Work Order ID 60270

Item Name: Basket Hoop

DESIGN #	DRAWN BY CP	DART AEROSPACE LTD HAWKESBURY, ONTARIO, CANADA	
CHECKED #	APPROVED #	DRAWING NO. D3166	REV. A SHEET 1 OF 1
DATE 02.07.10		TITLE BASKET HOOP	SCALE NTS
A	02.07.10	NEW ISSUE	
A1	04.04.08	38+/-1 WAS 36.0

DRAWING NO. D3166	TITLE BASKET HOOP	REV A1	DART AEROSPACE LTD ENGINEERING ORDER		D.E.O. NO. D3166-A-2	SHEET NO. 1 OF 1	SCALE NTS
DRAWN AJS	CHECKED <i>[Signature]</i>	MFG. APPR. <i>[Signature]</i>	APPROVED <i>[Signature]</i>		DE APPR. <i>[Signature]</i>		
DATE 08.12.11	DATE 08.12.15	DATE 08/12/15	DATE 08/12/16		DATE 08.12.16

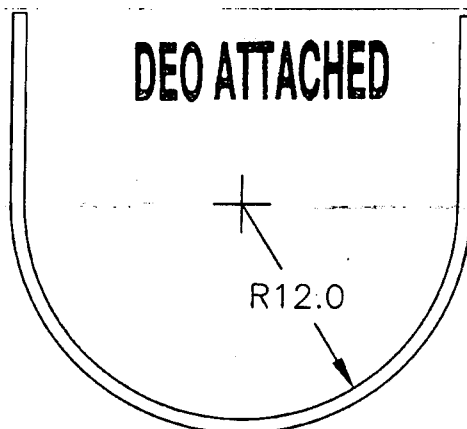
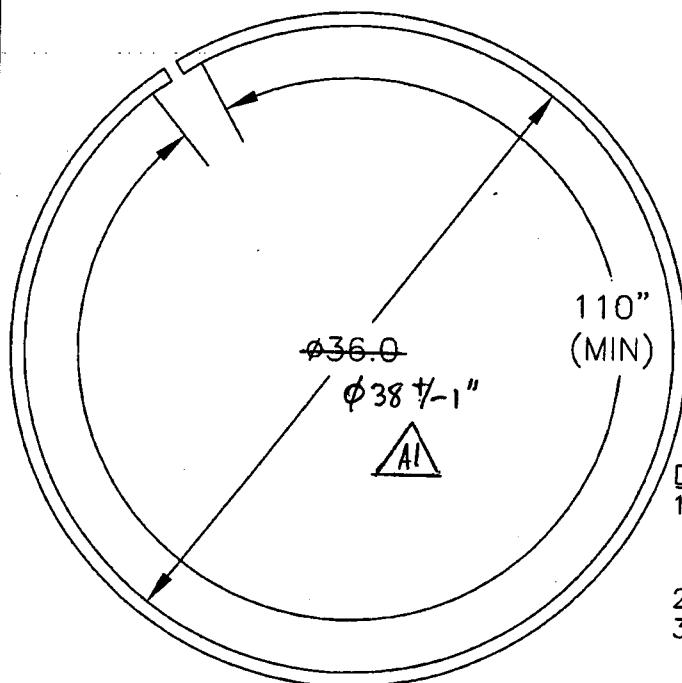
1) MODIFY MATERIAL NOTE FOR D3166-1 AS SHOWN:

- 1) MATERIAL: AISI 304/316 SS, 3/4 X 3/4 X 0.065 WALL SQUARE TUBING,
60.00" LONG
REF. DART SPEC M304TS0.750W.065

- 1) MATERIAL: AISI 304/316 SS SQUARE TUBING,
0.75" x 0.75" x 0.063 WALL, 60.00" LONG
(REF DART SPEC. M304TS0.750W.063)

2) MODIFY MATERIAL NOTE FOR D3166-3 AS SHOWN:

- 1) MATERIAL: AISI 304/316 SS, 3/4 X 3/4 X 0.065 WALL SQUARE TUBING,
120.00" LONG
REF. DART SPEC M304TS0.750W.065

- 1) MATERIAL: AISI 304/316 SS SQUARE TUBING,
0.75" x 0.75" x 0.063 WALL, 120.00" LONG
(REF DART SPEC. M304TS0.750W.063)

REASON: SEE PAR 08-005
